Plan Development, LLC

Re: Stanley and Rebecca Roberts. Applications to develop Tolovana Park Block 1 Lot 13.

August 6, 2020 ADDENDUM: Response to City Planner August 3, 2020 Letter.

Addendum to address the City Planner August 3, 2020 request for additional information
Application for Building Permit Tolovana Park Block 1 Lot 13 for Stanley and Rebecca Roberts
August 5, 2020

STANLEY ROBERTS
TAX LOT 600 - NENANA AVENUE
VEGETATION REMOVAL PLAN

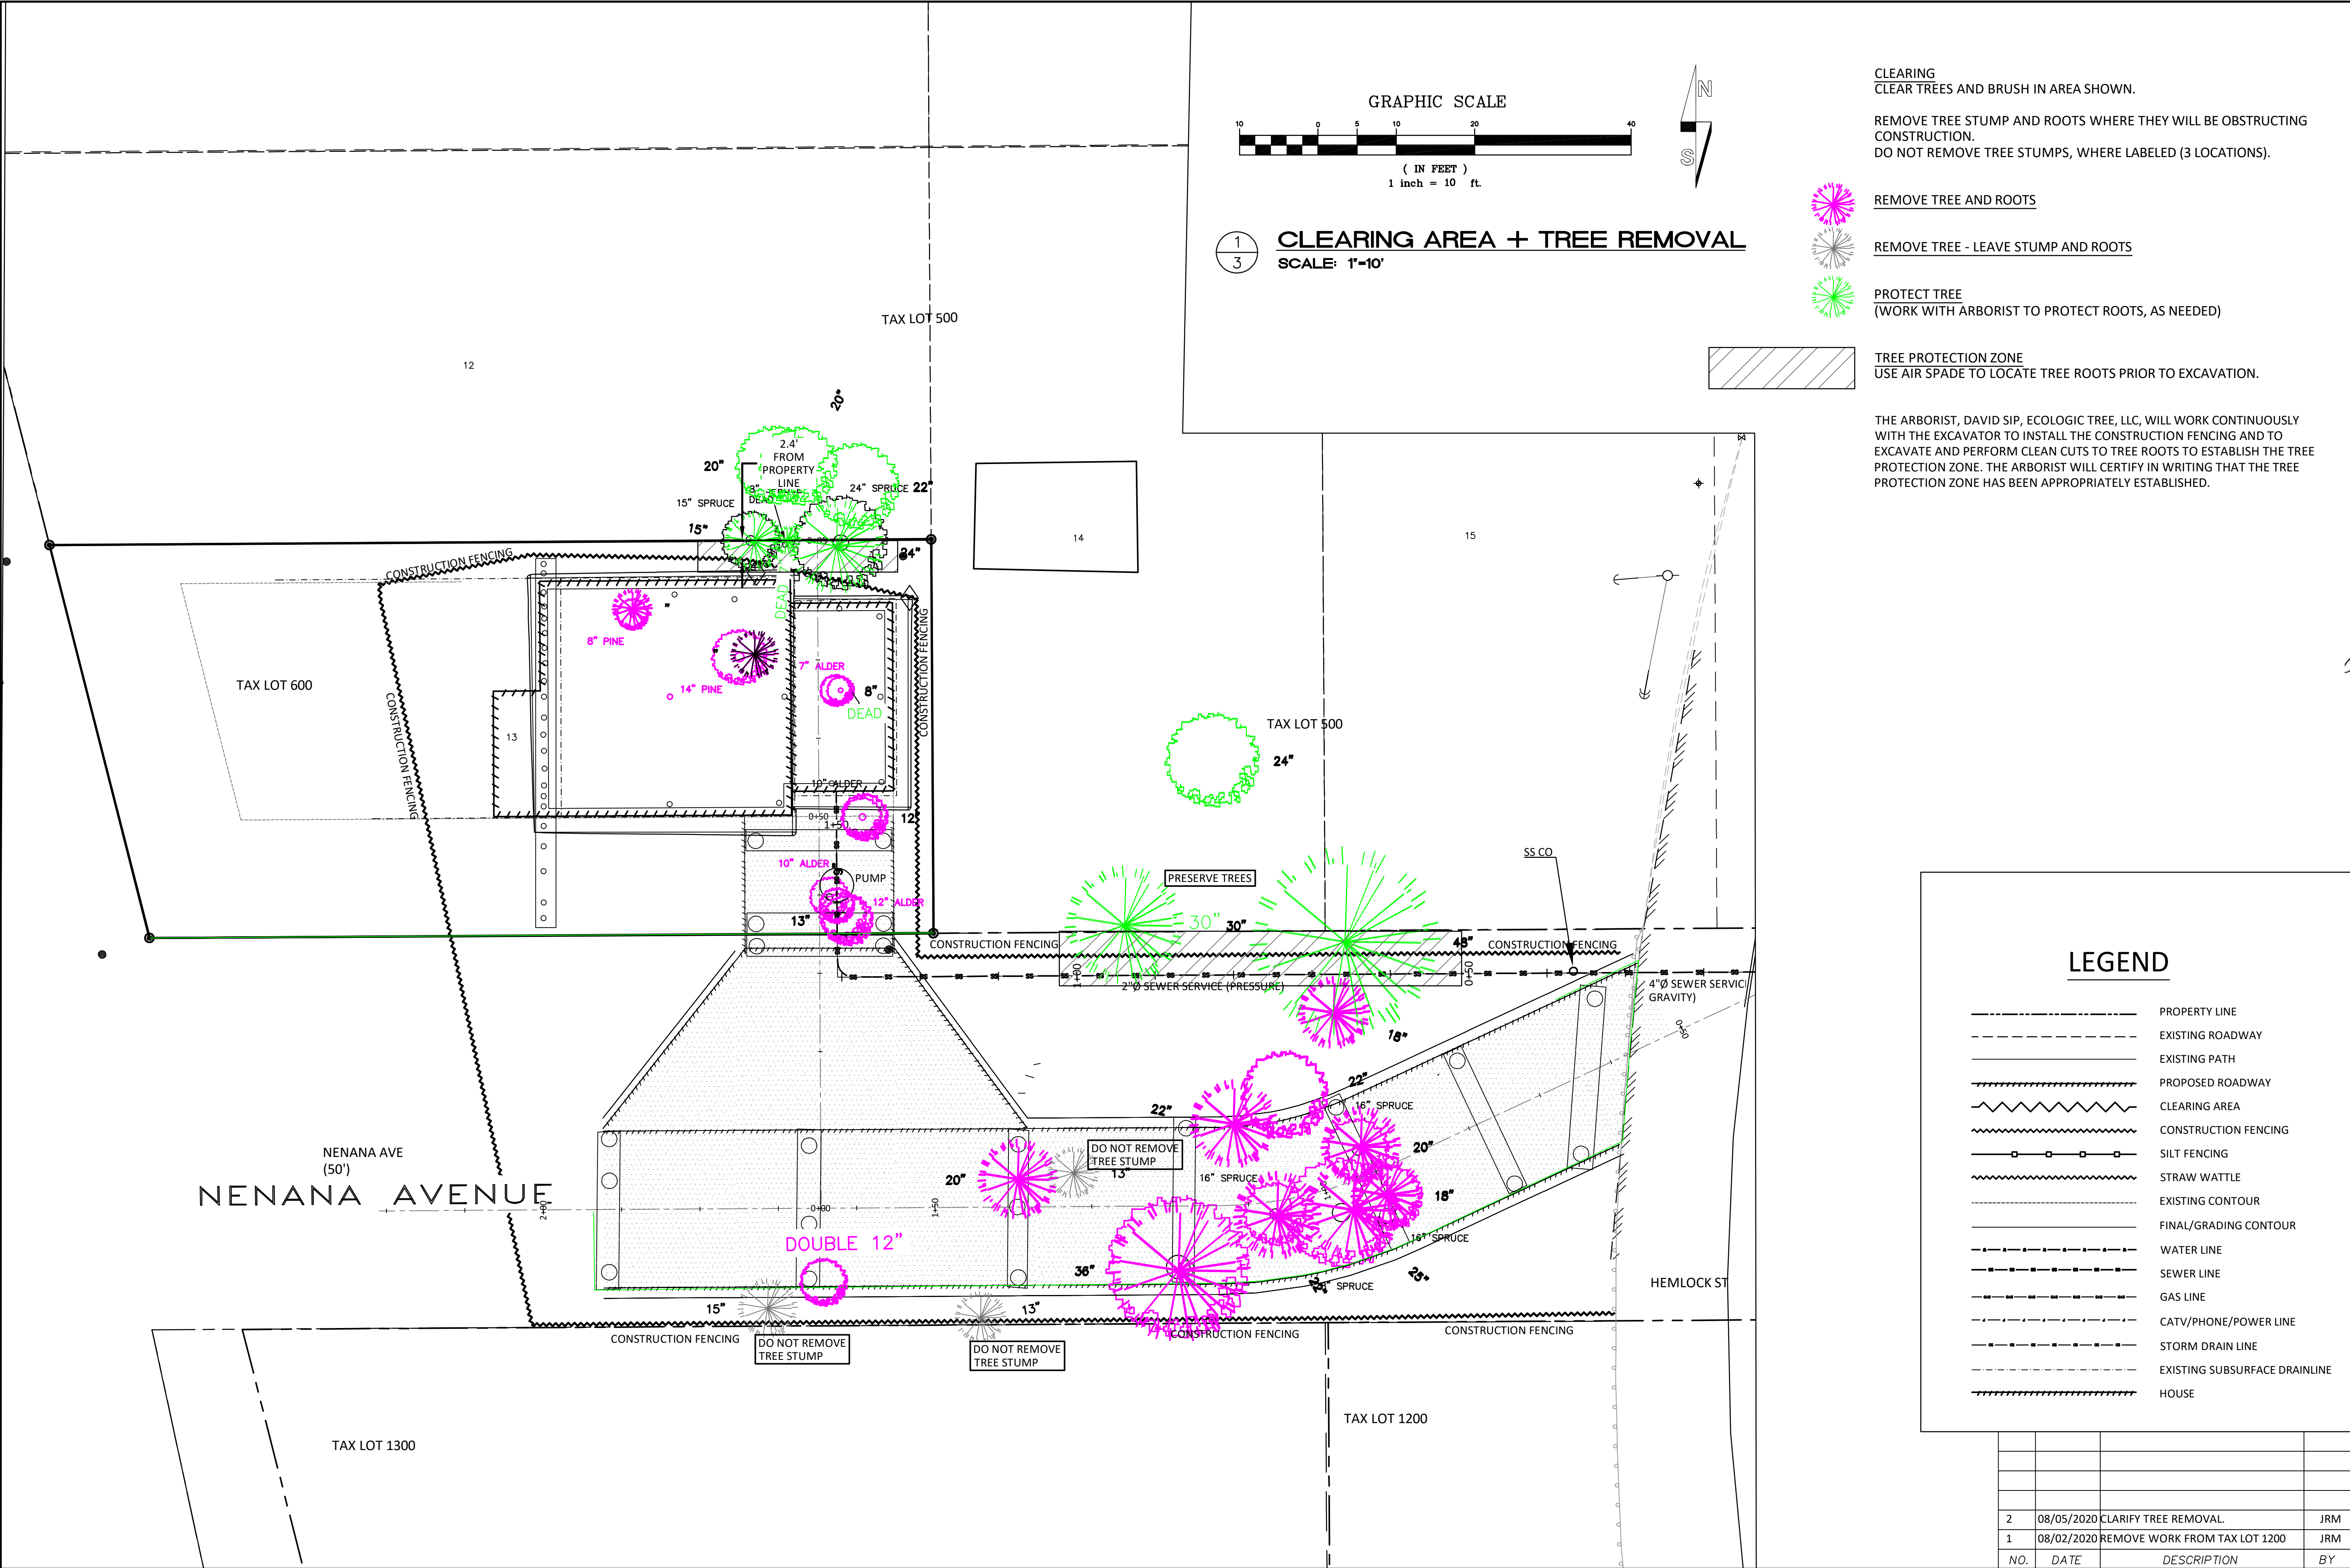
REMOVE TREE STUMP AND ROOTS WHERE THEY WILL BE OBSTRUCTING
CONSTRUCTION.
DO NOT REMOVE TREE STUMPS, WHERE LABELED (3 LOCATIONS).

2	08/05/2020	CLARIFY TREE REMOVAL.	JRM
1	08/02/2020	REMOVE WORK FROM TAX LOT 1200	JRM
NO.	DATE	DESCRIPTION	BY

SITE PLAN

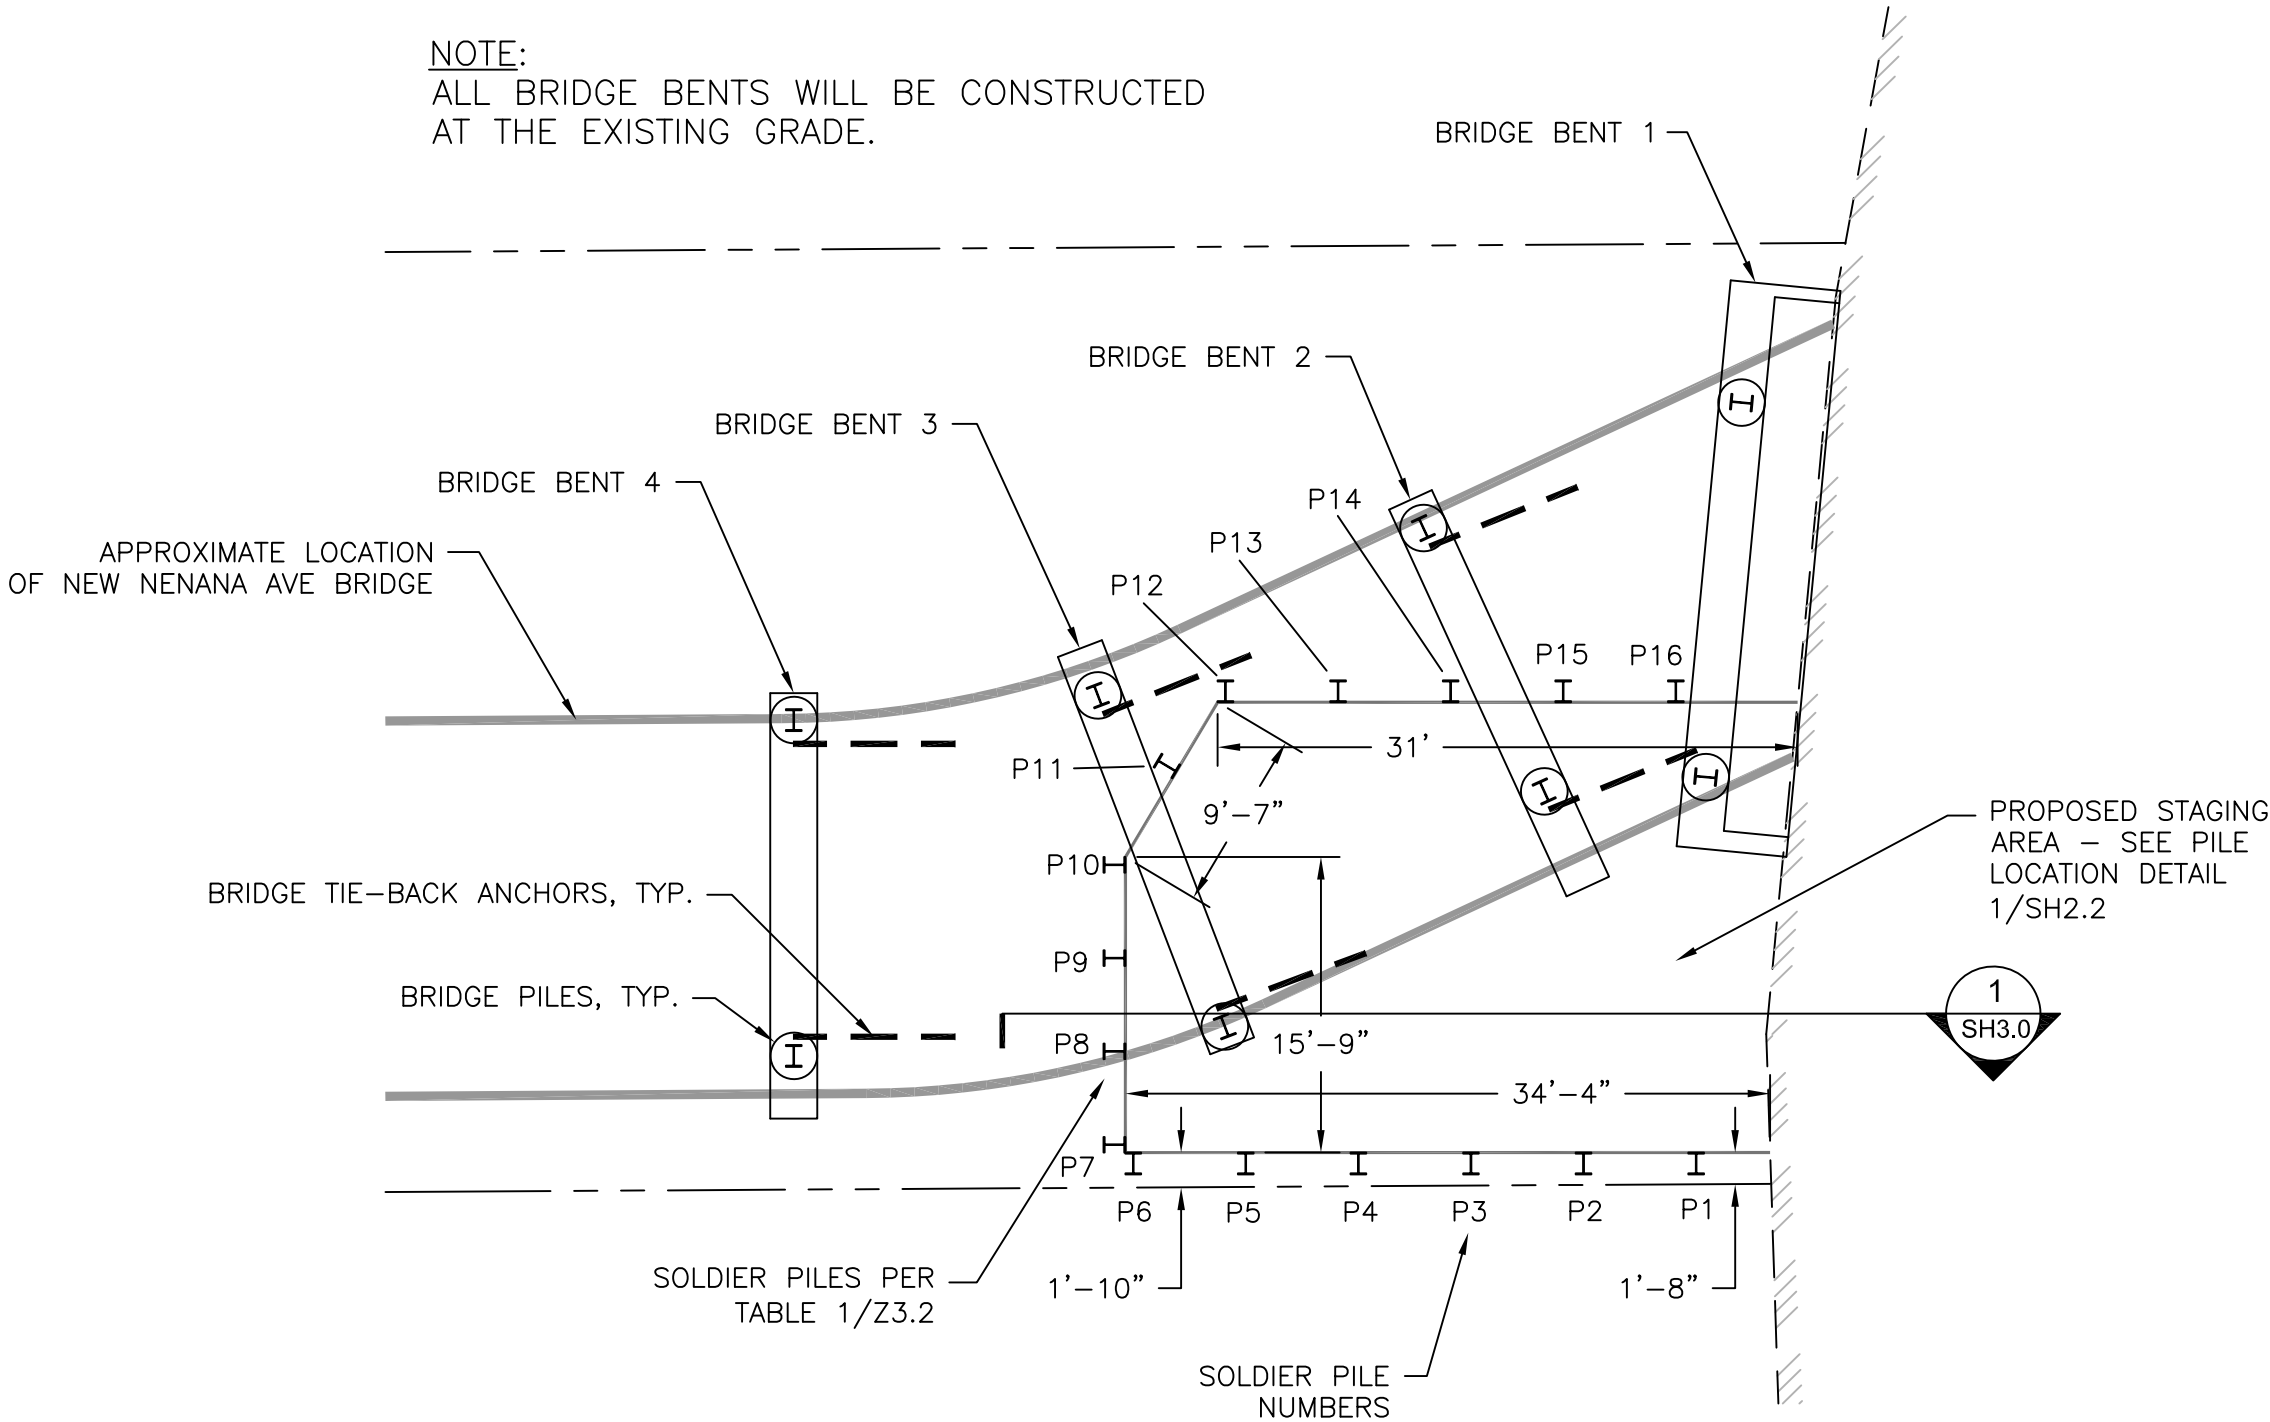
Attached documents from the Geotechnical Engineers, Civil Engineer and Certified Engineering Geologist, identify that the Staging Area is relocated to the Nenana right-of-way. Development of Tax Lot 1200 is not requested.

This Nenana Avenue Staging Area Plan replaces the Staging Area previously proposed on Tax Lot 1200.

Figure 1 – Portion of Roberts Staging Area, plan sheet Z2.0 showing Erosion Control Fence.

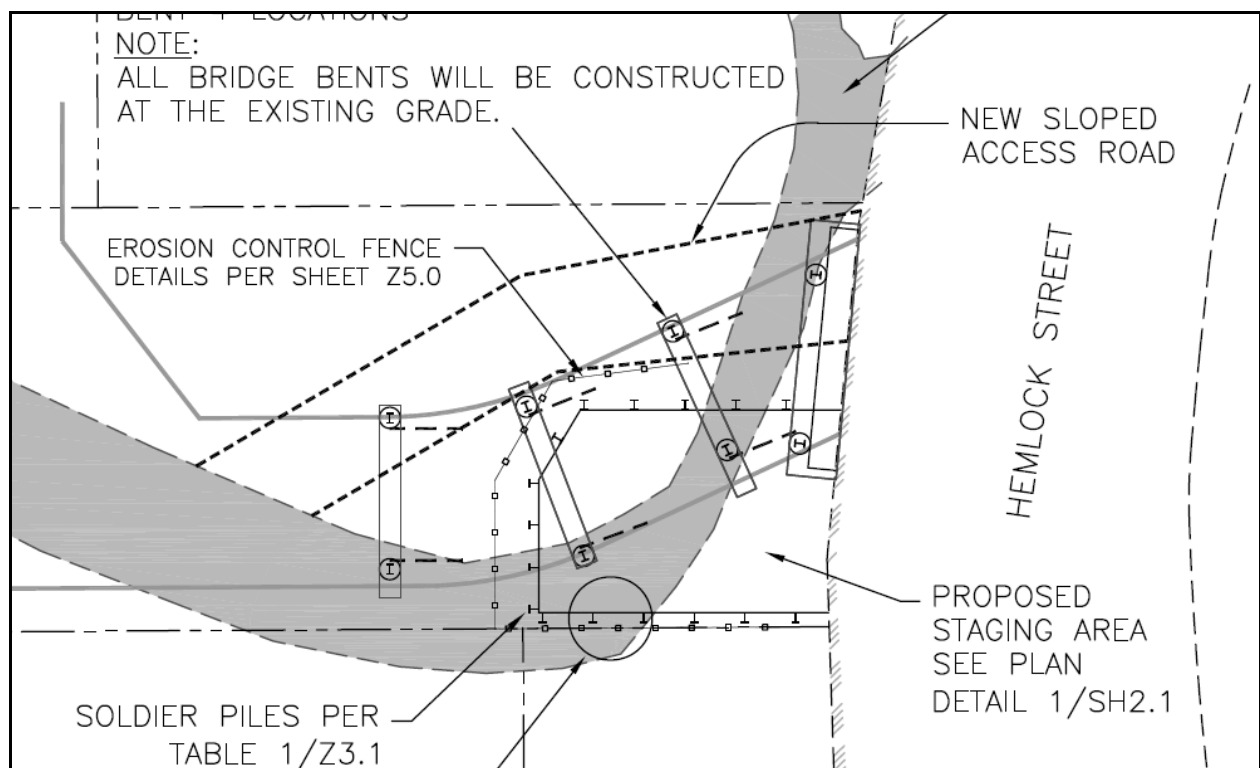
From my engineering geologic perspective, I feel the plans are acceptable and demonstrate appropriate thought and planning to enable the proposed construction to proceed into fall weather, if necessary. As I note in my email communication, I advocate placing erosion control fence as high on the slope as possible to containing drilling spoils and fluids. If this foundation drilling project extends into wet weather it may be necessary to install and maintain multiple layers of erosion control fence below the area of concentrated soldier pile drilling, see Figure 1. The well graded crushed rock access ramp currently in place behind the Hemlock Street guard rail (see Photo 1), in my opinion, can serve as its own erosion control media if it is protected from over washing fines from up slope drilling operations.
